D868UV firmware update V1.18 and V2.18

D868UV firmware update V1.17 and V2.17

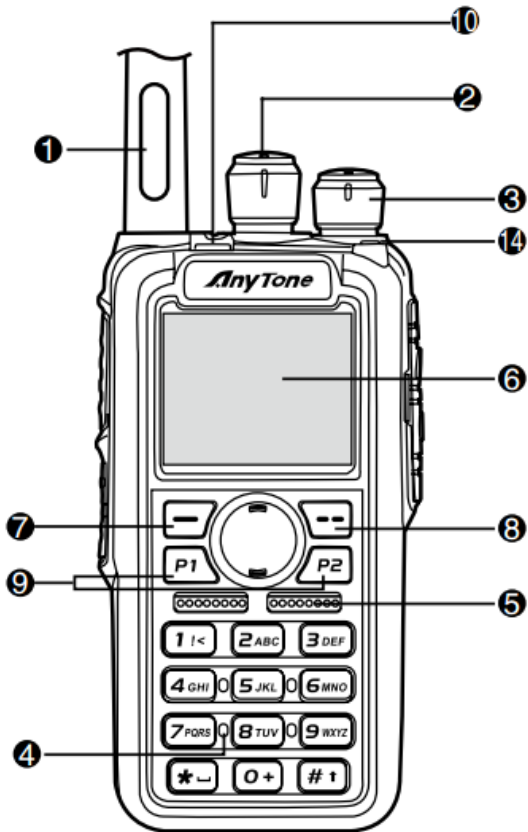
Remote Monitor -- When this function is on, in radio, you can dial a private ID and choose Remote Monitor, then you can hear from the other radio without the radio press PTT key.

Get GPS Position -- When this function is on, in radio, you can dial a private ID and choose Get GPS Position, then you can get the other radio's GPS position.
